[Docket No. NHTSA-2010-0162]

Rear Visibility; Federal Motor Vehicle Safety Standard, Rearview Mirrors; Federal Motor Vehicle Safety Standard, Low-Speed Vehicles; Phase-in Reporting Requirements

ACTION: Notice of proposed rulemaking; corrections.

Correction of Errors

Figure 6. Countermeasure Performance Test Area Illustration and Required Test Object Locations

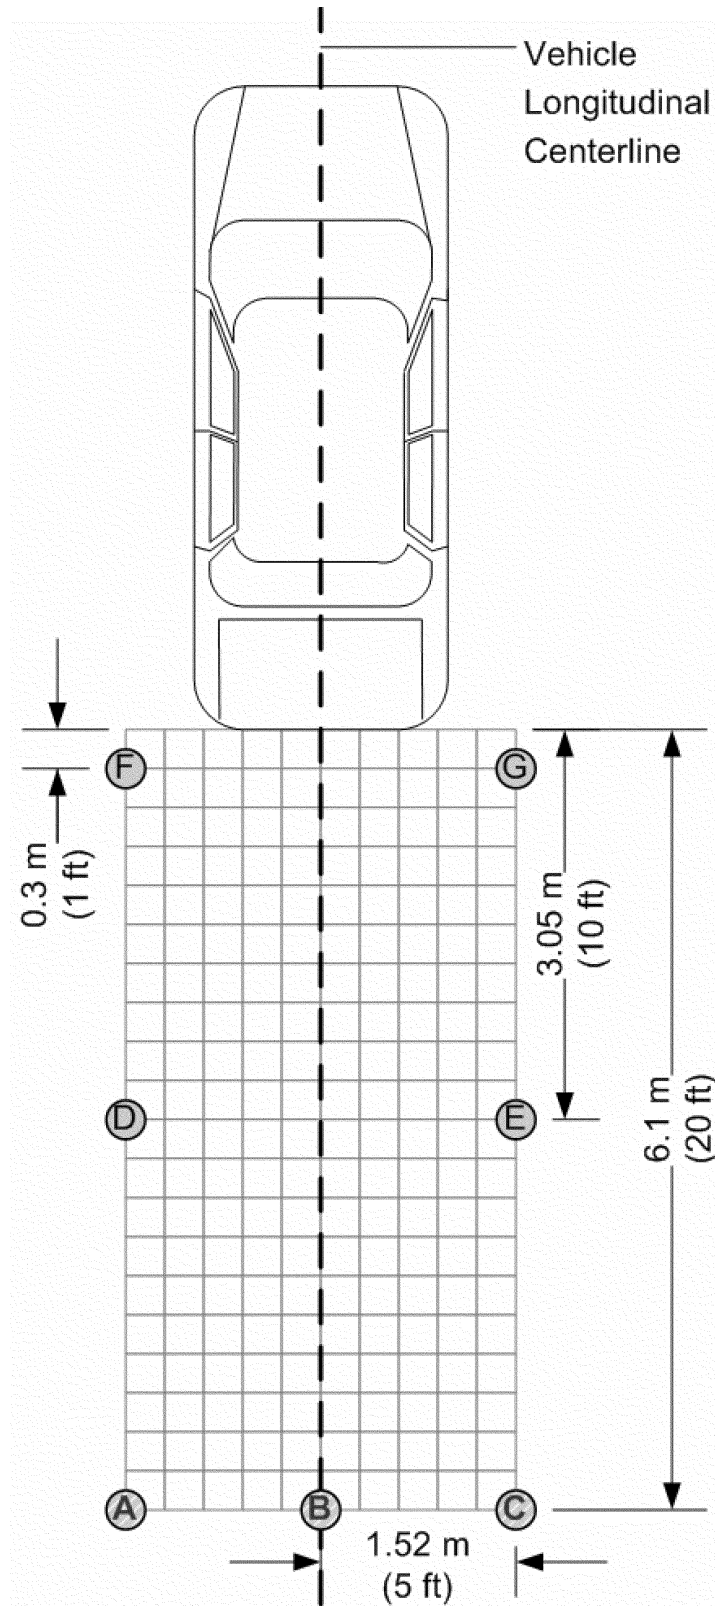
2. On page 76234, figure 6 is corrected to read as follows:

FIGURE 5: TEST CYLINDER LOCATIONS (Units in meters)

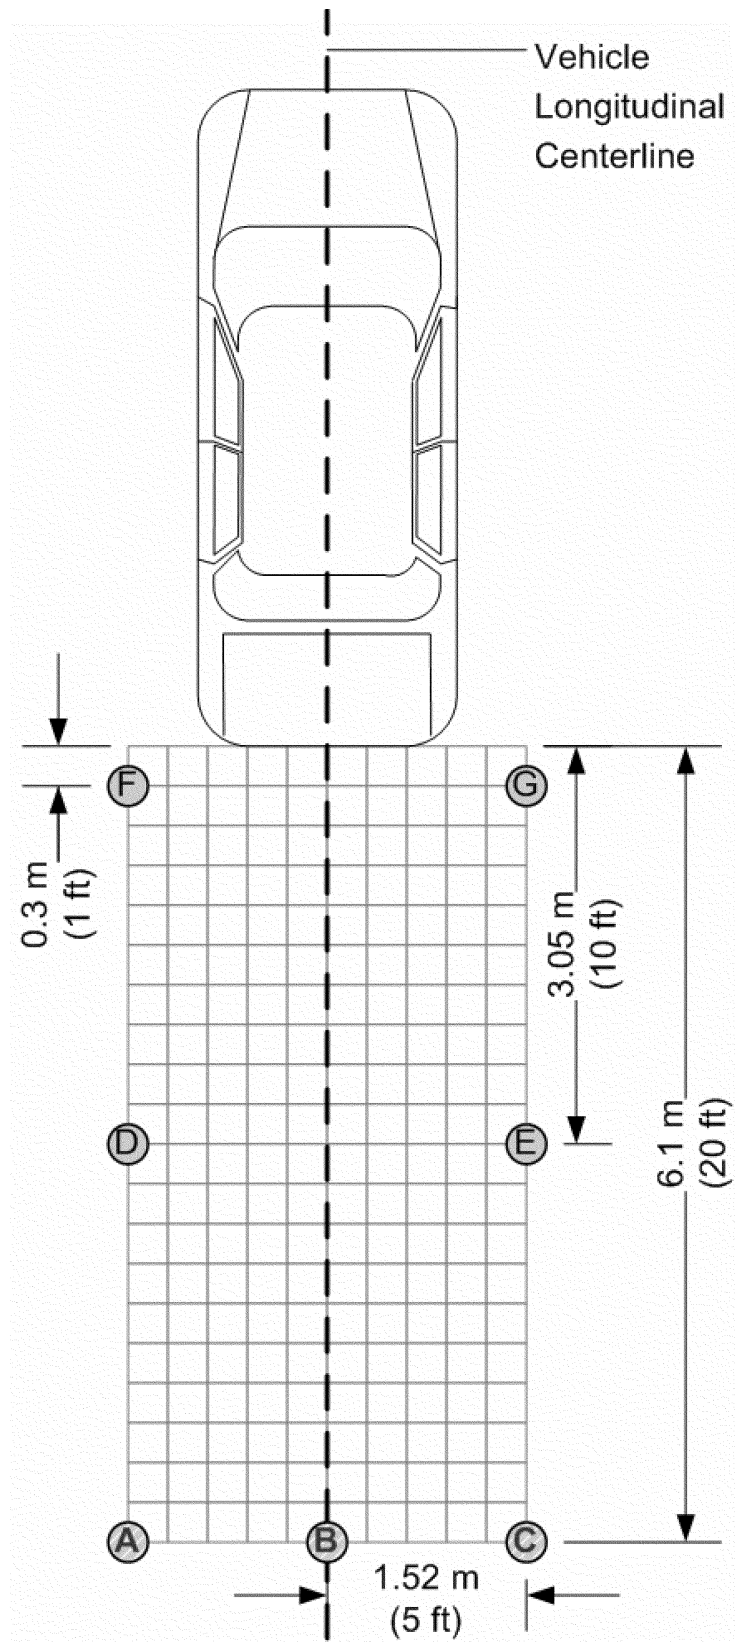
24. On page 76248, Figure 5 is corrected to read as follows:
